HQDFM Design for Manufacture(DFM) Report

File name: 0000A328399_1

Time: 2025-02-24Layer count:4

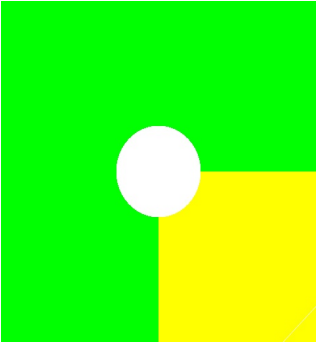
ID	Check	Limits	Value	Issue	Image	Position	Qty	Level
1	Copper-to-Board Edge_Copper-to-Board Edge	8,15,20	0.00 mm	<p>For most factories, the copper-to-board edge clearance requirement is 0.2 mm. Failure to meet the factory's requirements could increase the risk of exposed copper on the edge of the boards or damaged traces/pads, which decrease manufacturing efficiency and yield, and affect the reliability of the boards. Copper-to-board edge spacing of 0.00mil was detected in your design. It is recommended to increase the spacing to at least 0.25 mm for edge routing and 0.4 mm for v-cuts (v-cut spacing may depends on board thickness).</p>		0.00,114.05	4	Risk
